From: [REDACTED]
To: [REDACTED]
CC: [REDACTED]
Sent: 2/23/2021 3:00:52 PM
Subject: RE: O8W-PM [REDACTED] - Bucks Creek 1101 Phase 1,2&3 - Pre-Engineering Meeting

Subject: O8W-PM [REDACTED] Bucks Creek 1101 Phase 1,2&3 - Pre-Engineering Meeting

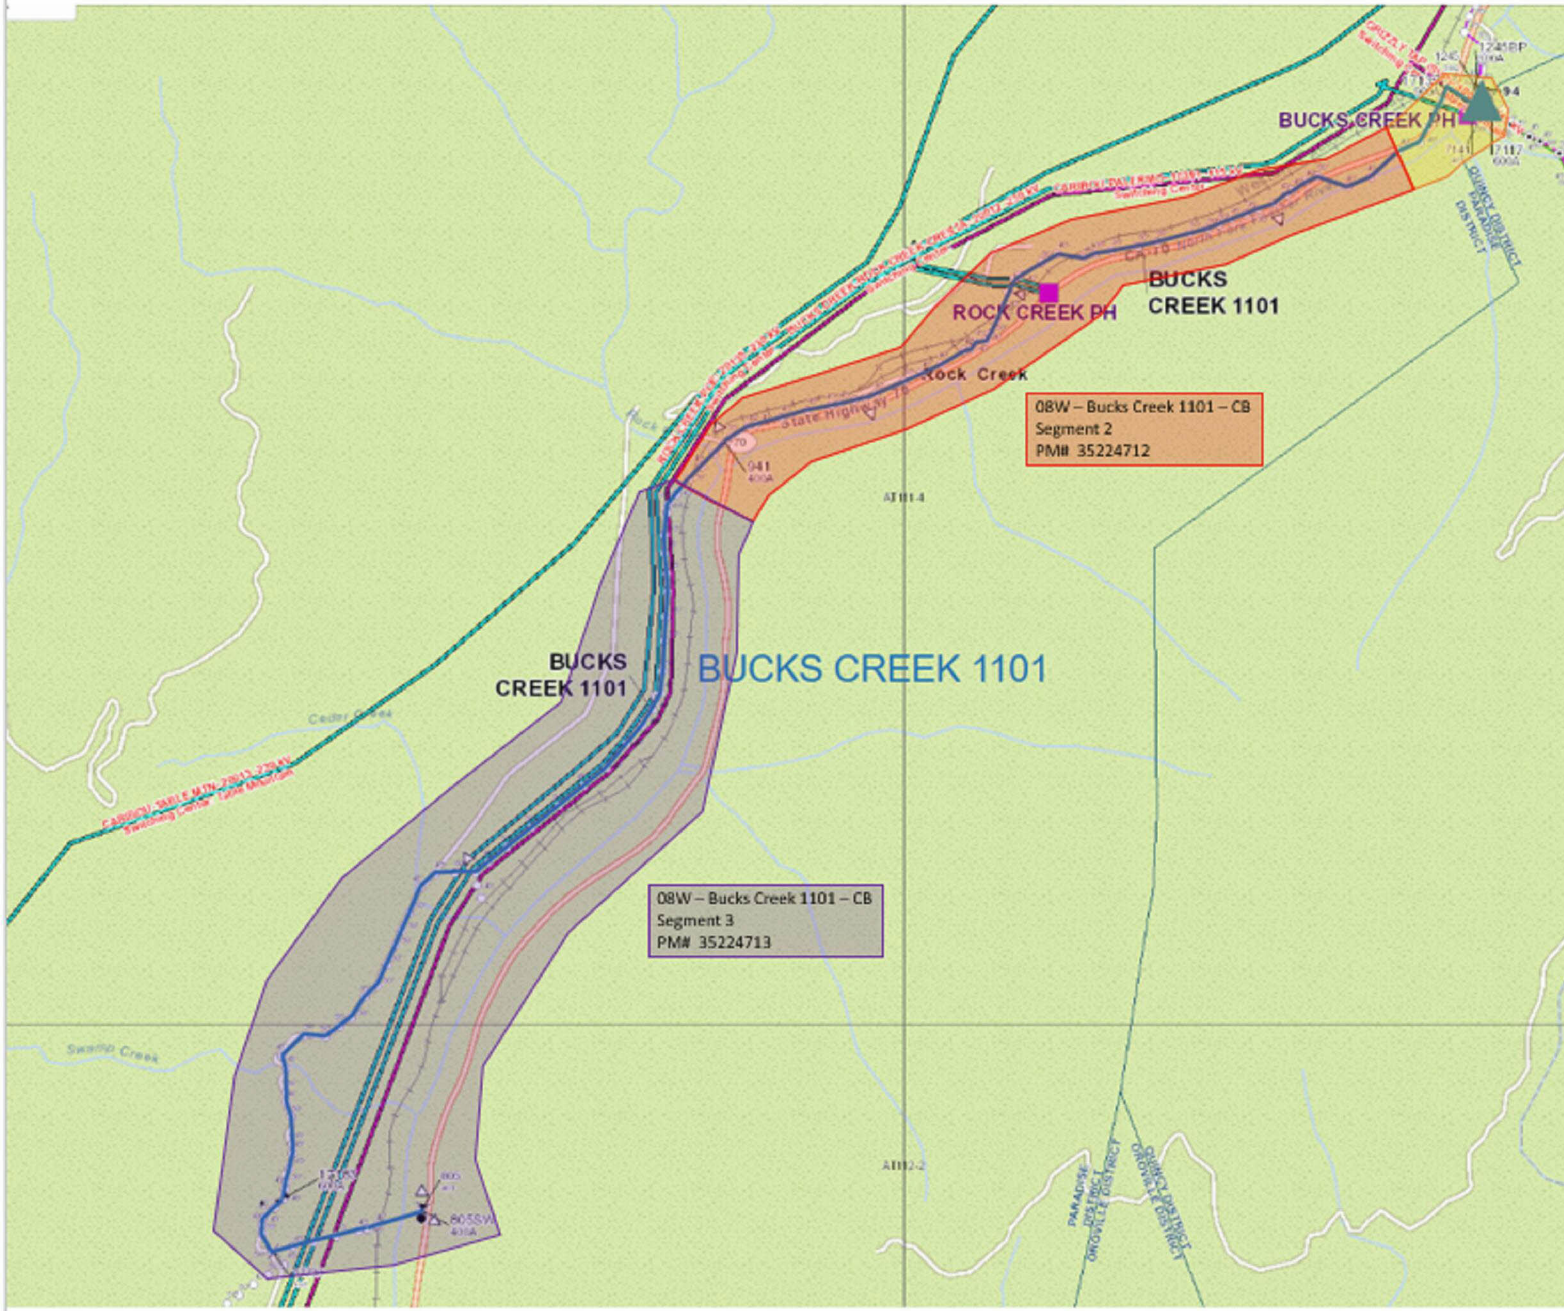
Attached are the 'base-map' limits in a kmz. file. As you will see, we need our base-map to go about ~100' into the tunnel at the south end (see pedestal in picture below....please begin about ~50 beyond this point which is about ~100' beyond the Cresta Dam).

We want to end the base-map at the sign location below which is roughly at MM (Mile Marker) 5.10.
